Index 102-628 Two-Way Left Turn Lanes

COMMENTARY

COMMENTS AND RESPONSES

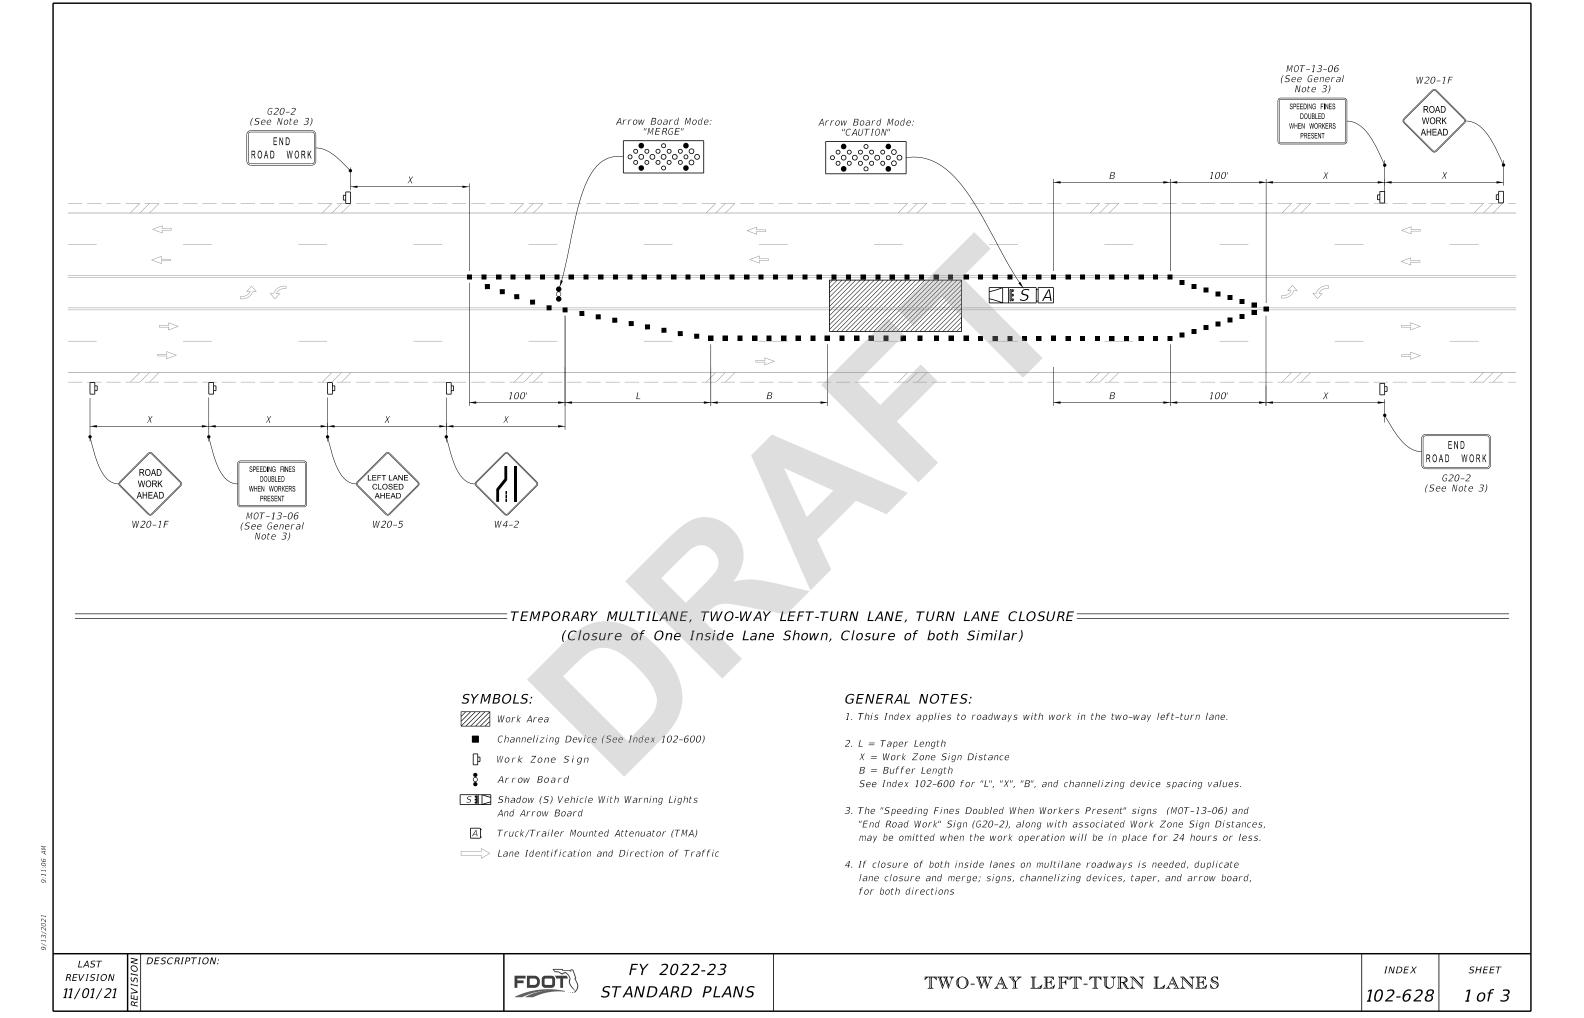
- On sheet 1 for traffic headed to the right, it seems that the arrow board should remain in "MERGE" mode rather than changing it to "CAUTION" mode since there is a lane closure for that direction of travel.
- On sheet 3, W1-4 or W24-1 signs may be more appropriate than the W20-5aR sign shown, since it is a lane shift not a lane closure.

RESPONSE: Agreed, this will remain in "MERGE" mode. For Sheet 3, I agree that the W1-4 WZ sign is more appropriate than the W20-5aR.

Change Made: On Sheet 1, revert the arrow board back to "MERGE" mode. Sheet 3 will be updated to have the W20-5aR sign replaced with the W1-4L. Date: 9-10-2021
